## GLISAN COMMONS - PHASE II

DESIGN REVIEW 01.09.2014

CARLETON HART  
ARCHITECTURE

MASSING REVISIONS - CURRENT

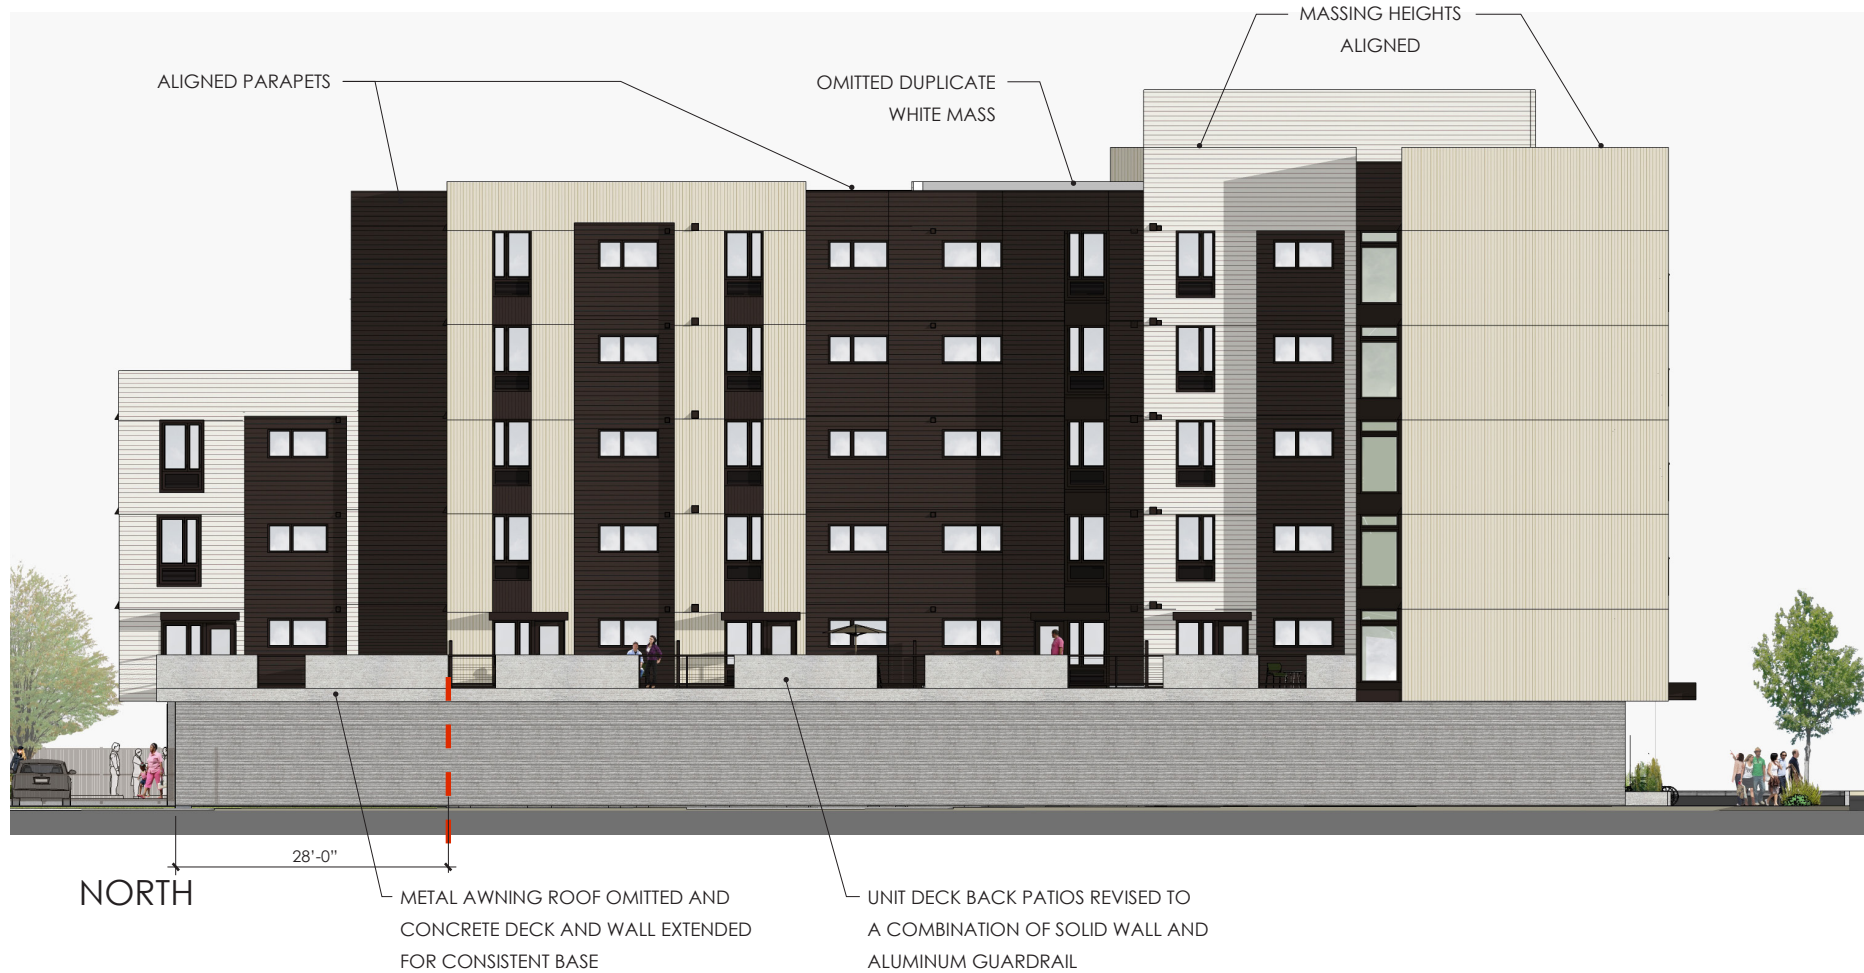
- SIMPLIFY NUMBER OF FORMS
- APPROACH BOX MASSINGS AS PRIMARY DESIGN CONCEPT
- APPLY RIGOR TO BUILDING HEIGHT AND FORMS
- SIMPLIFY MASSING AT EAST STAIR TOWER
- RELATE WEST GARAGE WALL TO NORTH WALL

NE 99TH AVE. WEST ELEVATION - DR HEARING 12.04.13

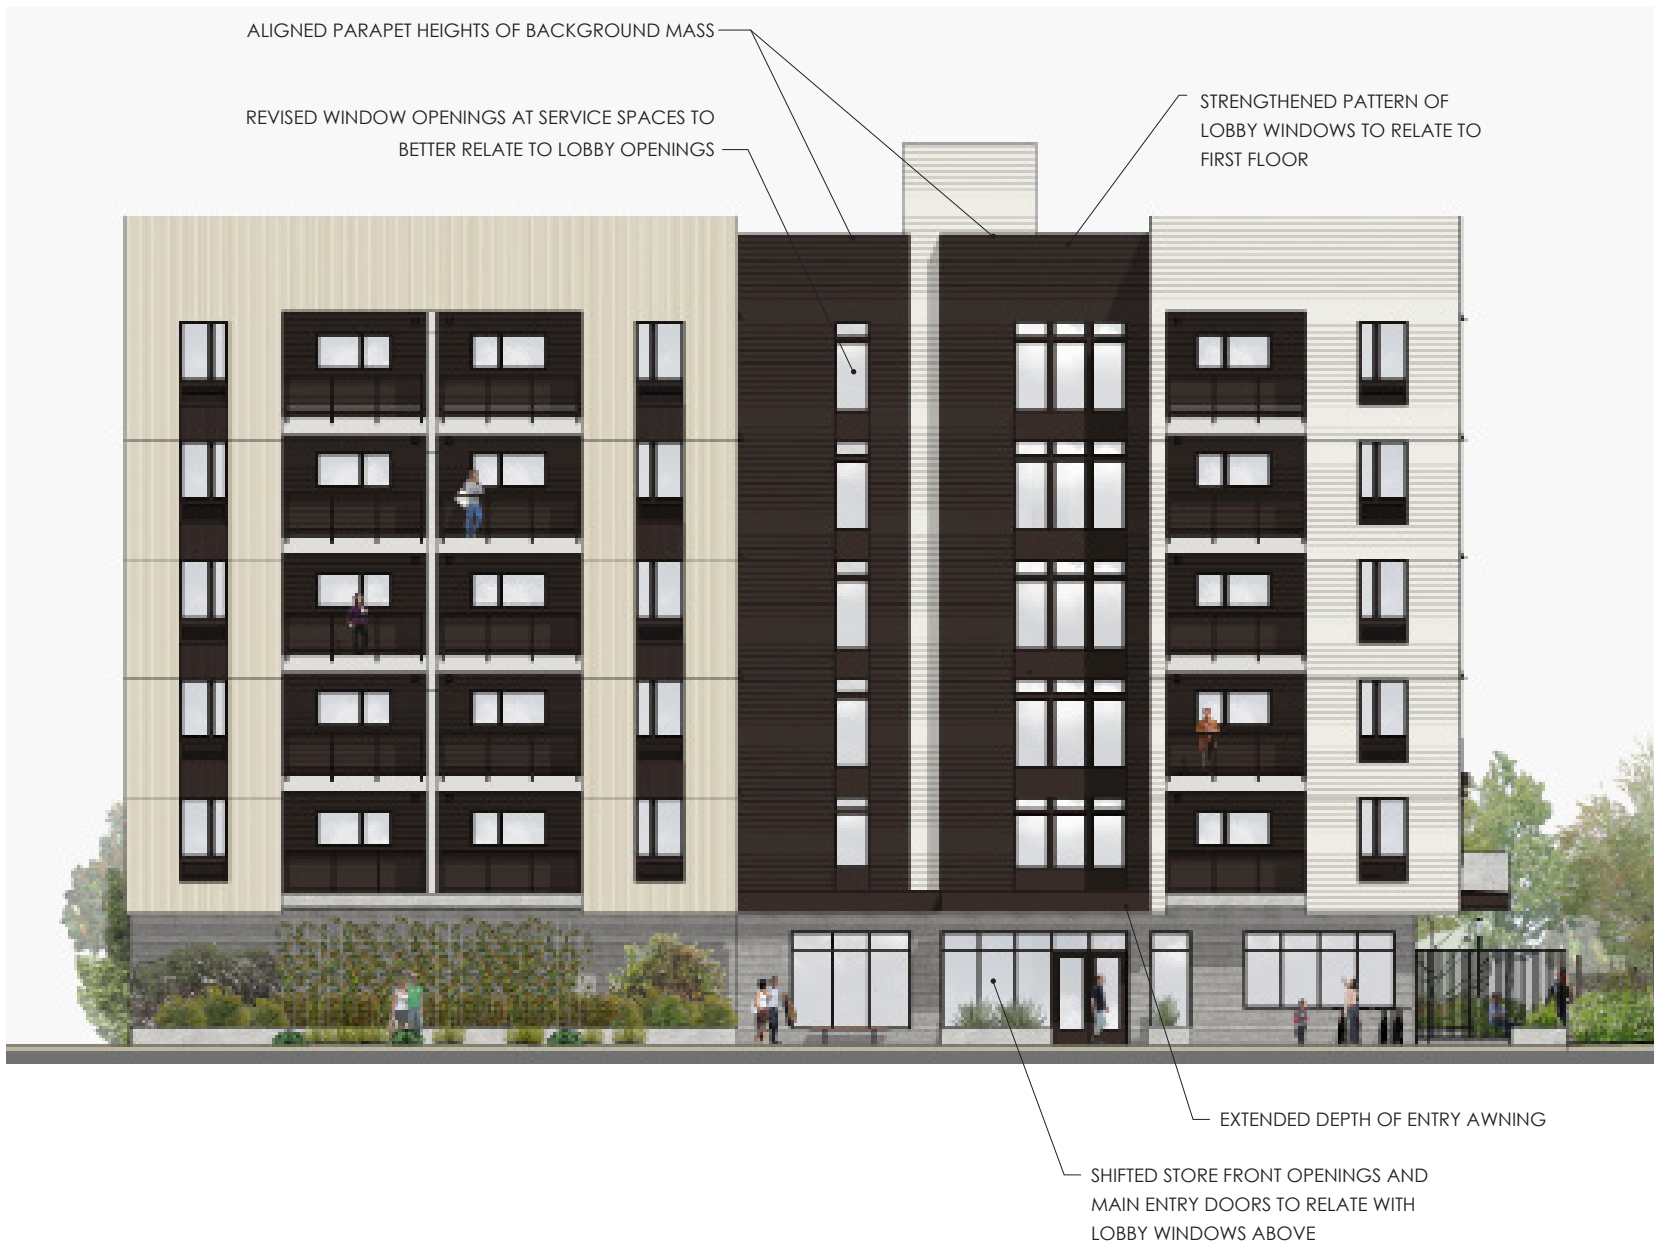
- SIMPLIFY RECESSED FORMS & MATERIALS
- RELATE MAIN ENTRY TO MASSING ABOVE
- CLARIFY THE ELEVATION AND BUILDING ENTRY

# PATH/COURTYARD DESIGN REVISIONS

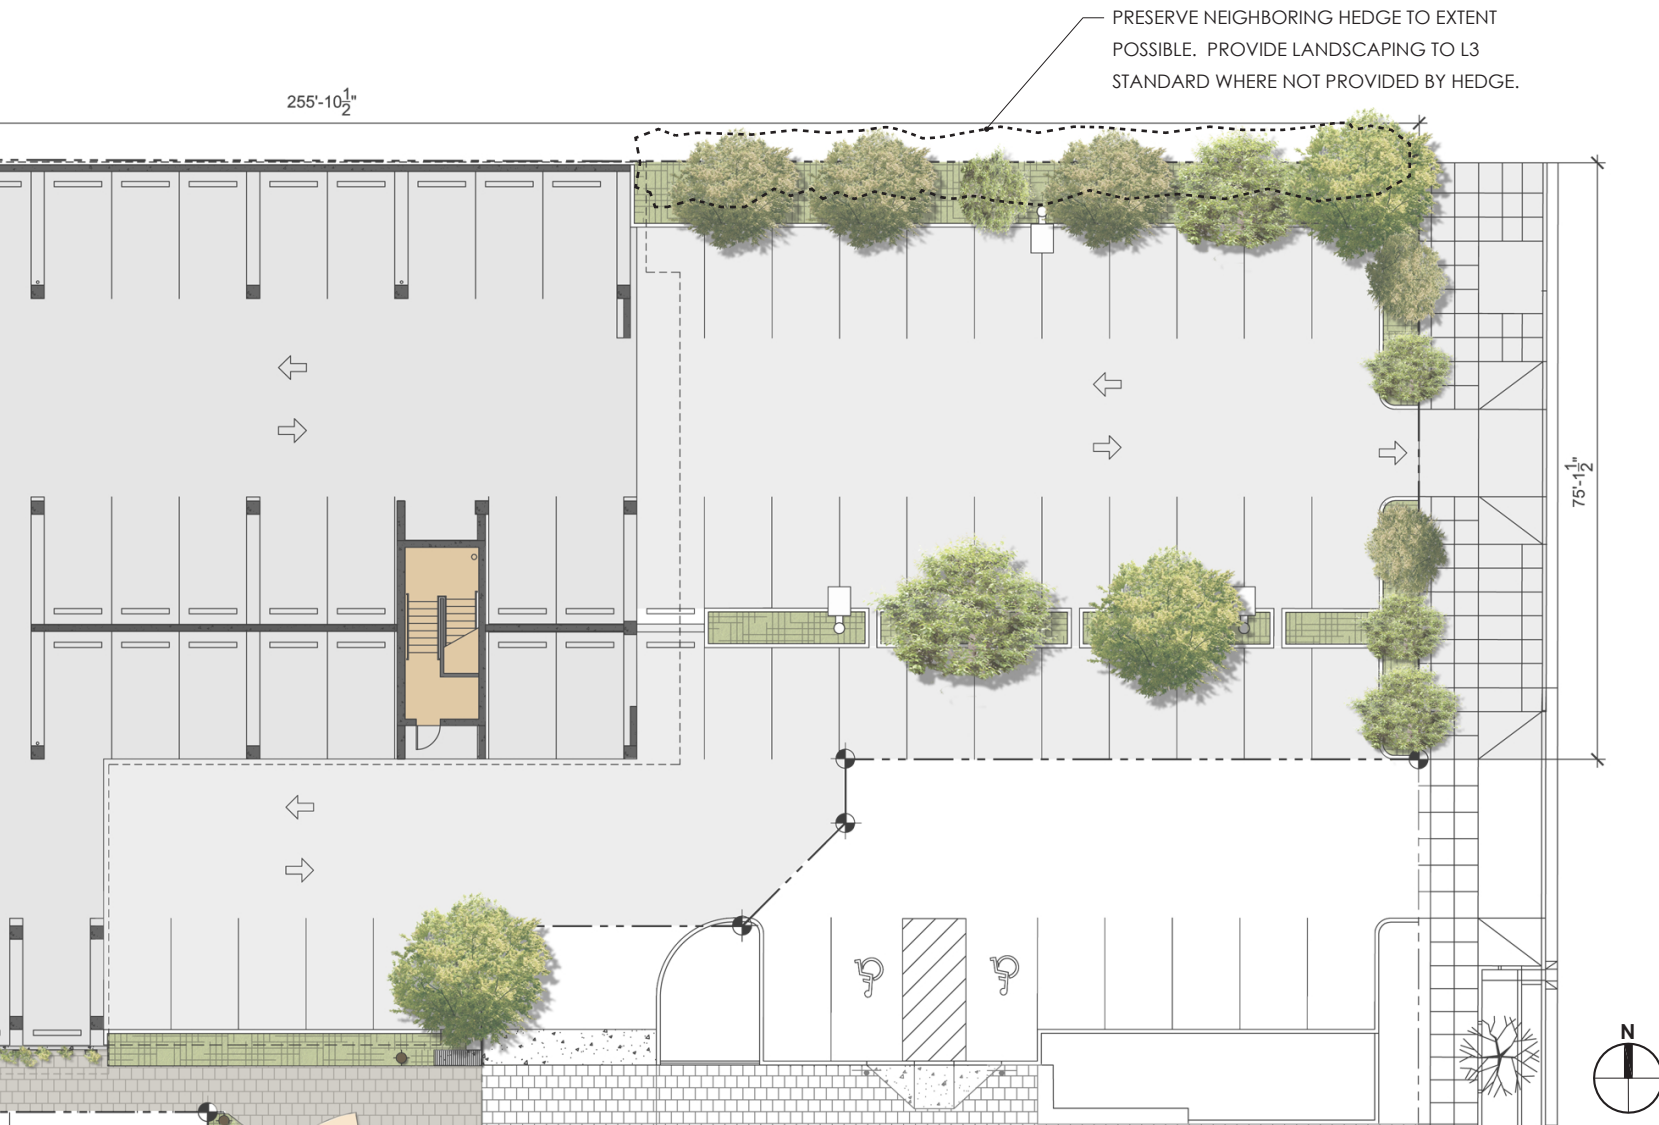
- MOVED COURTYARD BENCH FROM OBSTRUCTING WALKWAY
- REVIEWED PAVING MATERIALS & STRENGTHEN CONNECTION BETWEEN GARAGE ENTRY AND EAST-WEST PATH
- CONCERN FOR ADJACENCY OF PRIVATE UNIT PATIOS TO RAISED GARDEN PLAZA

# MODIFICATIONS

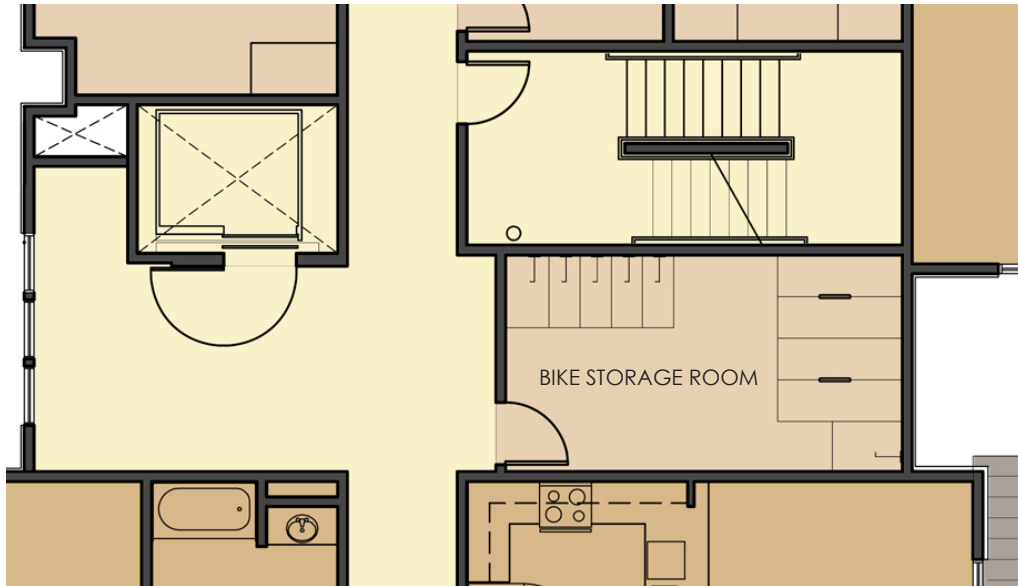
1. ALLOW 50 % INSTEAD OF 75% OF THE NE 99TH AVE. STREET FRONTAGE TO MEET THE ENHANCED PEDESTRIAN STREET STANDARDS.
2. PROVIDE LANDSCAPING IN LIEU OF PAVING TO BUFFER GARAGE, NOT INCLUDING TREES PER L2 STANDARD.
3. PROVIDE ALTERNATE LANDSCAPING WIDTHS AND MATERIALS ALONG SOUTH PARKING STALLS IN PLACE OF 5'-0" BUFFER
4. PROVIDE STAGGERED WALL MOUNT BIKE RACKS AT 1'-6" SPACING INSTEAD OF 2'-0" AND PROVIDE 50 LONG-TERM BIKE SPACES INSTEAD OF 66.

## MODIFICATIONS - BICYCLE STORAGE

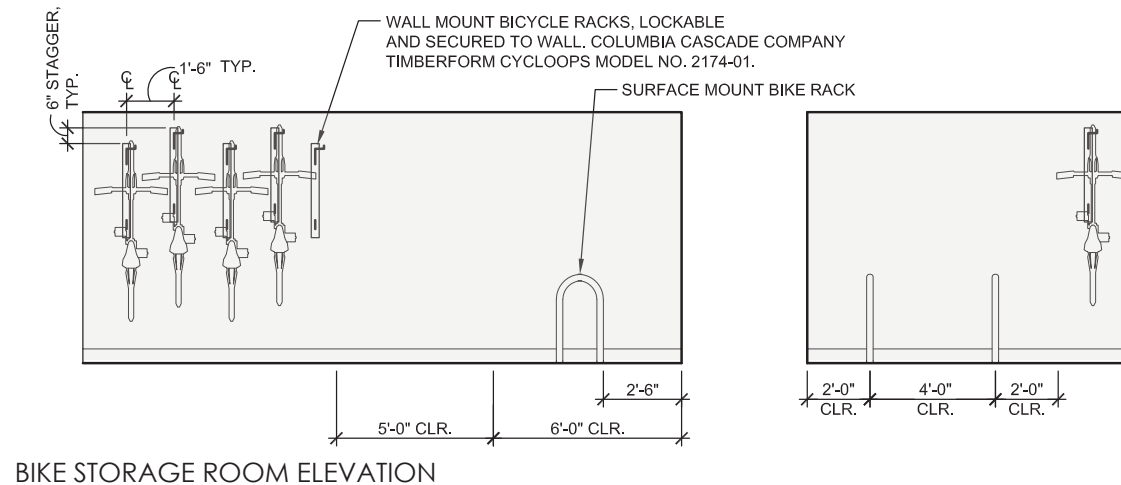
- BICYCLE STORAGE ROOM ON ALL 5 RESIDENTIAL FLOORS
- ADJACENT TO ELEVATOR
- TOTAL OF 50 SPACES
- 66 (1.1 PER UNIT) LONG TERM REQUIRED PER ZONING
- REQUEST A MODIFICATION TO REQUIRED SPACING TO PROVIDE MORE BIKE RACKS
- REQUEST A MODIFICATION TO REQUIRED NUMBER OF BIKE SPACES TO PROVIDE COMBINATION OF WALL MOUNT AND SURFACE MOUNT RACKS
